# **Final Environmental Impact Report**

Amendments to the Building Energy Efficiency  
Standards (2022 Energy Code)

**August 4, 2021**

**Docket Number 21-BSTD-02 | CEC-400-2021-007-F**

**Figure 1. Peaking Hourly Generation (2018)<sup>76</sup>**

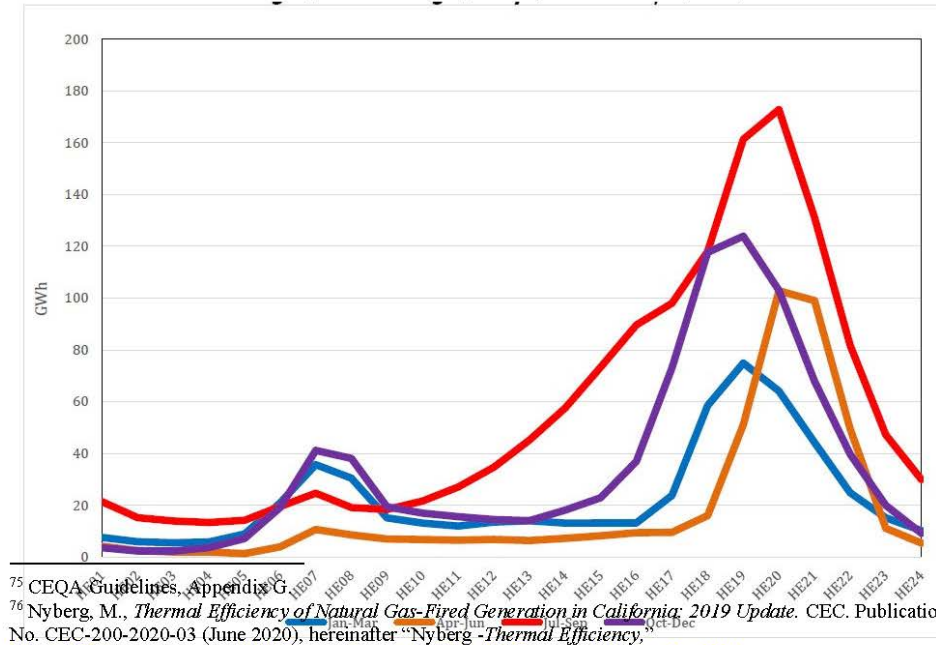
By looking at only seasonal peak demands, rather than the daily peak demands, the analysis masks the Project's potentially significant impact as wasteful and inefficient because a seasonal analysis fails to capture the true energy consumption patterns which alter significantly throughout the day.

D5-11

**Figure 2. Electricity Demand for HPWHs Relying On Electric Resistance<sup>82</sup>**

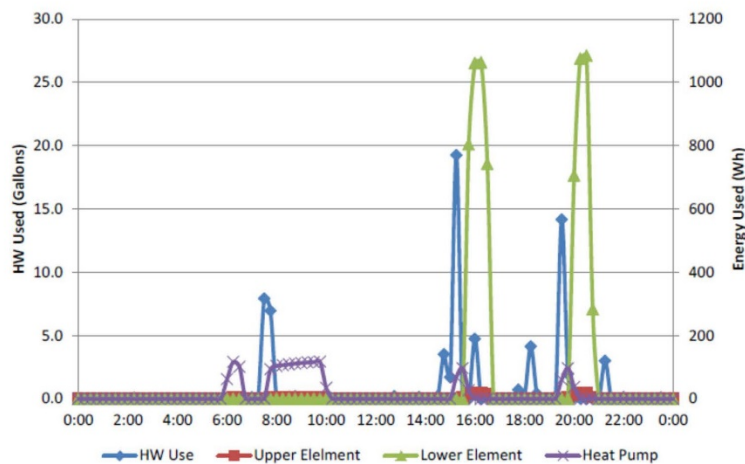
In addition, hot water demand also affects heat pump energy efficiency. As common sense would dictate, electricity consumption increases with overall water consumption. However, as demonstrated in Figure 2 below, if the hot water demands are intense, a hybrid

HPWH will revert into electric resistance mode, which consumes at least twice as much electricity as heat pump mode and would therefore greatly exacerbate energy impacts.<sup>81</sup>

D5-14  
con't

**Figure 3. Emissions Intensity Relative to Natural Gas<sup>90</sup>**

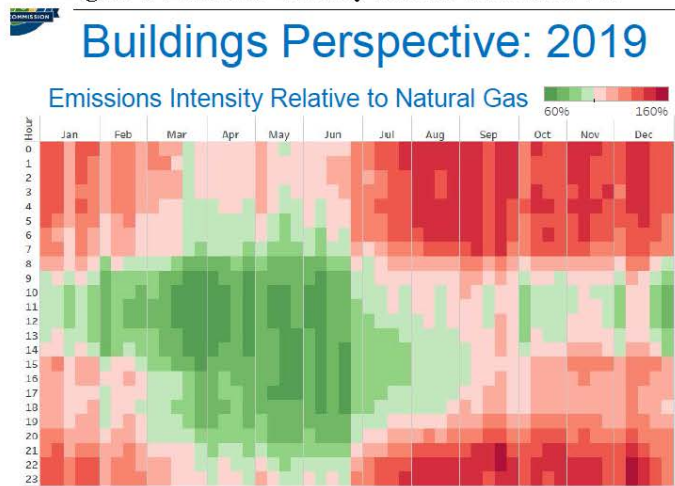
Although California has a larger proportion of renewable utility-scale energy than Maryland, the CEC has shown that in California, consistent with the NIST study, buildings that rely on natural gas generate substantially lower GHG emissions on average than buildings that rely on electricity. As shown in Figure 3 below, in 2018 the *CEC estimated that electricity use in buildings produces a greater level of GHG emissions than natural gas use for approximately 60 percent of the year.*<sup>89</sup> This is because natural gas results in lower GHG emissions during a significant majority of the morning and evening hours in all months, which are the periods of highest residential energy demand. The significantly lower GHG emissions in California buildings that rely on natural gas reflects the fact that, except during daytime hours from about March to June, intermittent solar and wind is insufficient to meet in-state building energy demand. When intermittent renewable energy is not available, electrical generation is less efficient and produces higher GHG emissions than if buildings were relying on natural gas.

D6-6

**Figure 1. Emissions Intensity Relative to Natural Gas<sup>36</sup>**

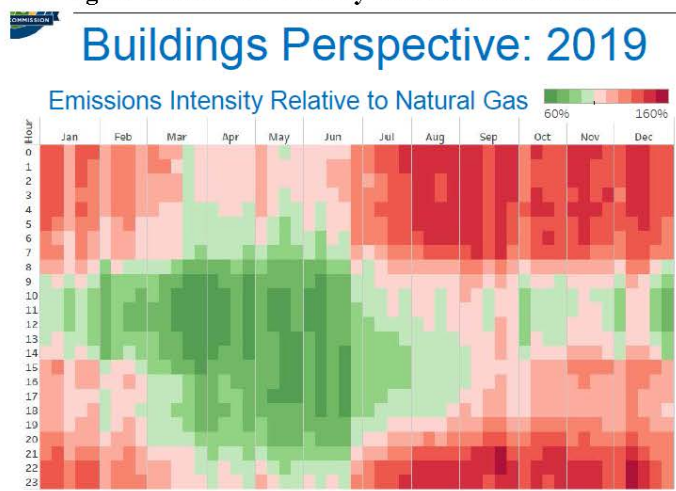
has a larger proportion of renewable utility-scale energy than Maryland, the CEC has shown that, consistent with the NIST study, in California buildings that rely on natural gas generate substantially lower GHG emissions on average than buildings that rely on electricity. As demonstrated in Figure 1, in 2018 the CEC estimated that electricity use in buildings produces a greater level of GHG emissions than natural gas use for approximately 60 percent of the year.<sup>35</sup> This is because natural gas results in lower GHG emissions during a significant majority of the morning and evening hours in all months, which are the periods of highest residential energy demand. The significantly lower GHG emissions in California buildings that rely on natural gas reflects the fact that, except during daytime hours from about March to June, intermittent solar and wind is insufficient to meet in-state building energy demand. When intermittent renewable energy is not available, electrical generation is less efficient and produces a greater level of GHG emissions than if the building were relying on natural gas.

**Figure 2. Electricity Demand for HPHWs Relying On Electric Resistance<sup>52</sup>**

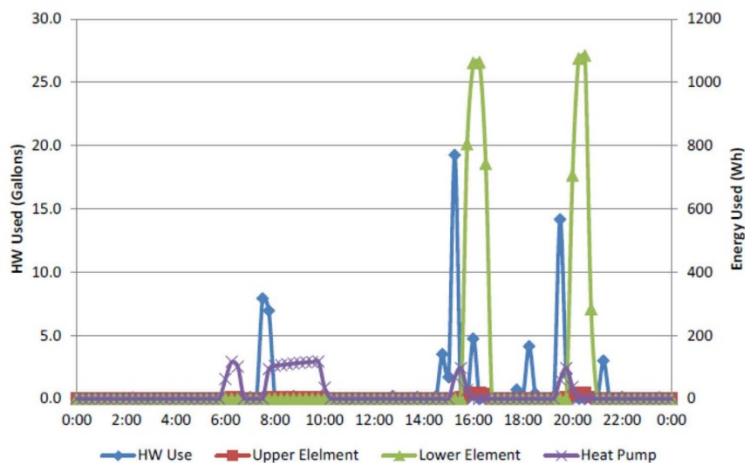
In addition, hot water demand also affects heat pump’s energy efficiency. As common sense would dictate, electricity consumption increases with overall water consumption. However, as demonstrated in Figure 2 below, if the hot water demands are intense, a hybrid HPHW will revert into electric resistance mode, which consumes at least as twice as much electricity when compared to heat pump mode and would therefore greatly exacerbate or increase energy impacts.<sup>51</sup>
